SUBJECT: THREE MILE ISLAND NUCLEAR STATION, UNIT 1
OPERATING LICENSE NO. DPR-50
DOCKET NO. 50-289
LICENSE CHANGE APPLICATION (LCA) NO. 286

TMI Unit 1 License Change Application No. 286
Safety Evaluation and No Significant Hazards Consideration Analysis

**Hand Markup of the Current TMI Unit 1 Technical Specifications Pages
for License Change Application No. 286**

TMI Unit 1 EMERGENCY FEEDWATER (EFW) SYSTEM

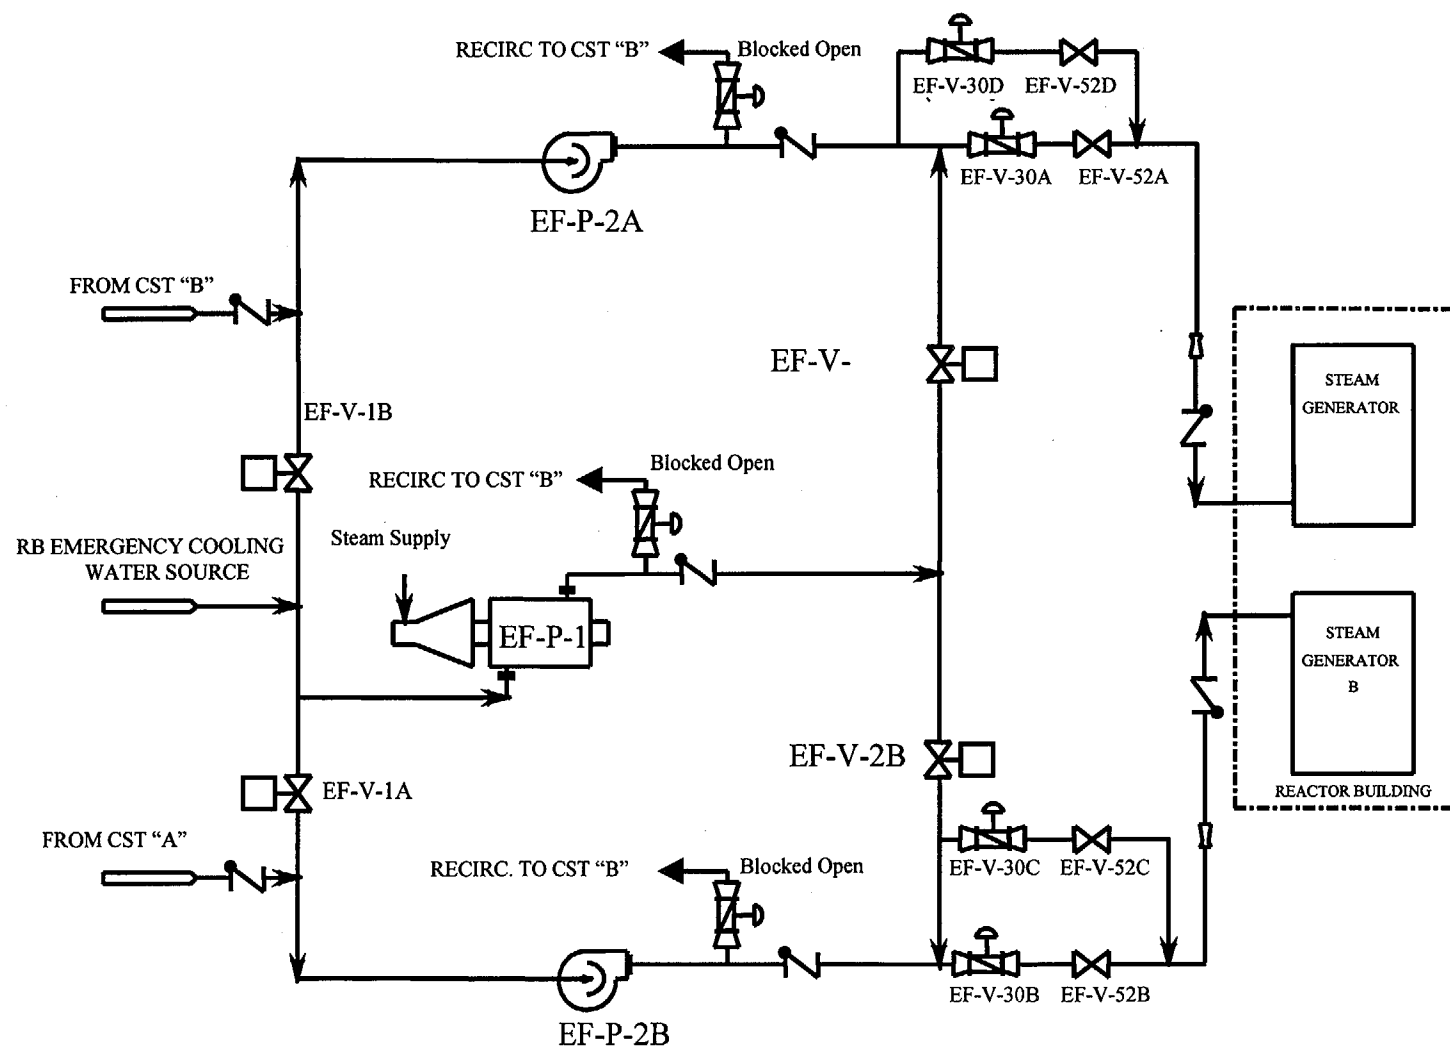
Amendment No. 124 incorporated the EFW long term upgrades required by NUREG-0737, Item II.E.1, including the safety grade Heat Sink Protection System (HSPS) for automatic initiation of EFW and OTSG water level control. One of the EFW long-term upgrades added a redundant EFW flowpath in the line to each OTSG. As such, each OTSG has two redundant flowpaths. Each redundant flowpath to an OTSG includes an automatic control valve and a

manual isolation valve. OTSG "A" has two flowpaths using EF-V-30A and EF-V-52A (Path A) or EF-V-30D and EF-V-52D (Path D). OTSG "B" has two flowpaths using EF-V-30B and EF-V-52B (Path B) or EF-V-30C and EF-V-52C (Path C). To accommodate the revised definition of an EFW flowpath and apply the concept of flowpath redundancy to the EFW LCOs, conforming changes are needed to the EFW System requirements throughout the TS for consistency and clarity.
